DSP-21033

Metropolitan East at Konterra Town Center

STAFF REPORT

SUBJECT: Detailed Site Plan DSP-21033
Type II Tree Conservation Plan TCPII-065-08-03
Metropolitan East at Konterra Town Center

Figure 4: Signage

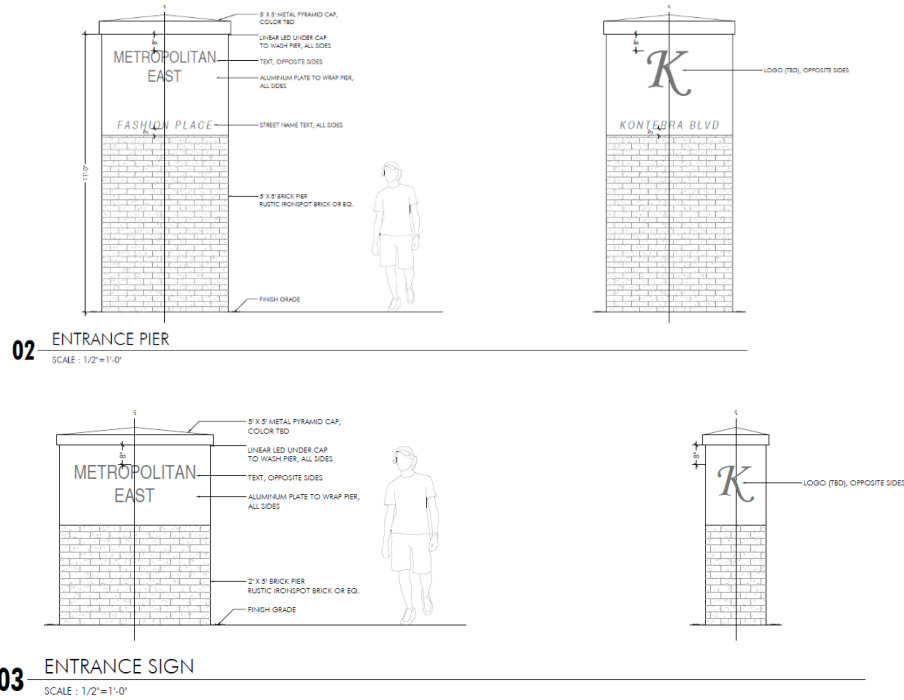
Eight freestanding entrance signs and two freestanding piers are located on-site. The 5-foot-wide freestanding entrance signs are brick columns, which are located at the entrances to the public roads and are approximately 6 feet tall. The signs include a metal cap with downward facing LED lighting to illuminate the name of the development. The piers are designed in a similar fashion and are located on the north and south sides of Fashion Place, at its intersection with Konterra Boulevard East. The 5-foot-wide piers are 11 feet tall and include a logo and the name of the development. The sign is acceptable; however, staff recommends that attractive year-round landscaping be proposed at the base of the signs and the piers to provide seasonal interest, and a condition requiring this has been included herein.

TYPE II TREE CONSERVATION PLAN

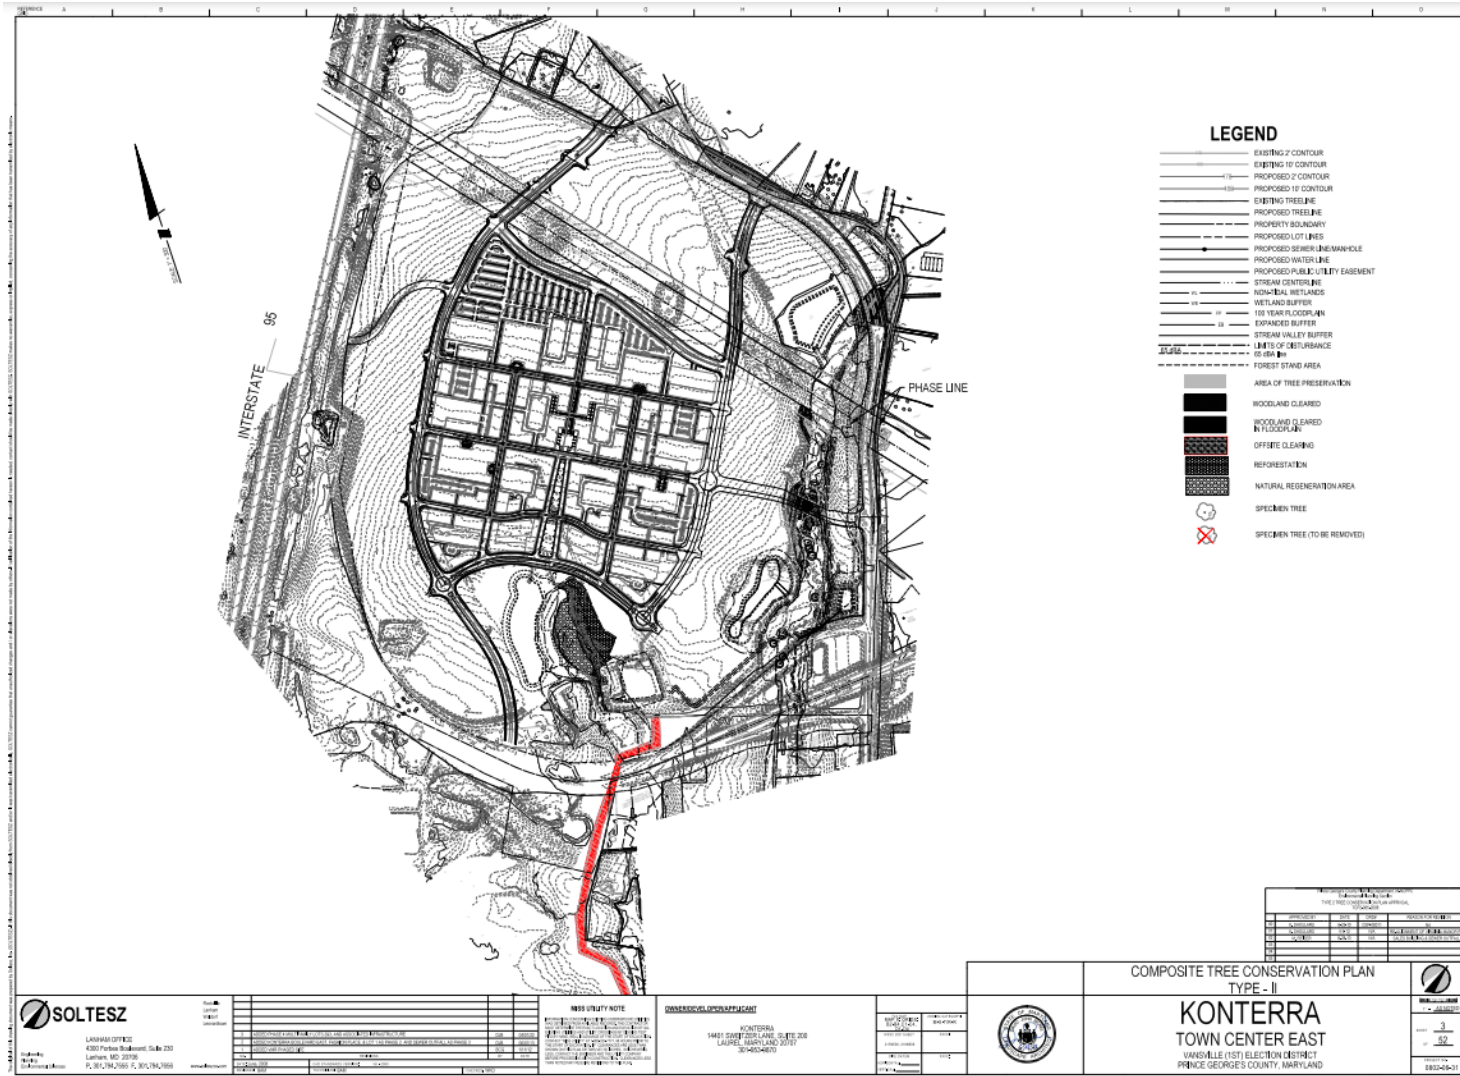
As previously discussed, an additional 0.59 acre of reforestation (Area No. 2) was proposed in the area of the abandoned WSSC easement, per TCPII/085/19; however, the current application shows no woodland preservation or reforestation in this area on Sheet 30 of TCPII/065/08-03. In addition, there appears to be a shading error associated with Woodland Preservation No. 10 (0.01 acre of woodland preservation) on this same sheet. The shading for this woodland preservation is shown across a much larger area within both the PEPCO utility rights-of-way, as well as across the associated easement to trim and remove trees. No woodland preservation or afforestation/reforestation is permitted within this area. The TCPII must be adjusted accordingly.

The current application shows no woodland preservation or reforestation in this area on Sheet 30 of TCPII/065/08-03. Staff recommends showing reforestation and preservation within this abandoned right-of-way instead of showing additional preservation off-site, since on-site preservation and reforestation is prioritized over off-site mitigation under current regulations.

- c. Remove all labels associated with the abandoned Washington Suburban Sanitary Commission (WSSC) rights-of-way.
 - (1) Add reforestation and woodland preservation, as appropriate, within the area of the abandoned WSSC rights-of-way. At a minimum, replace the reforestation that was previously shown on Sheet 30.
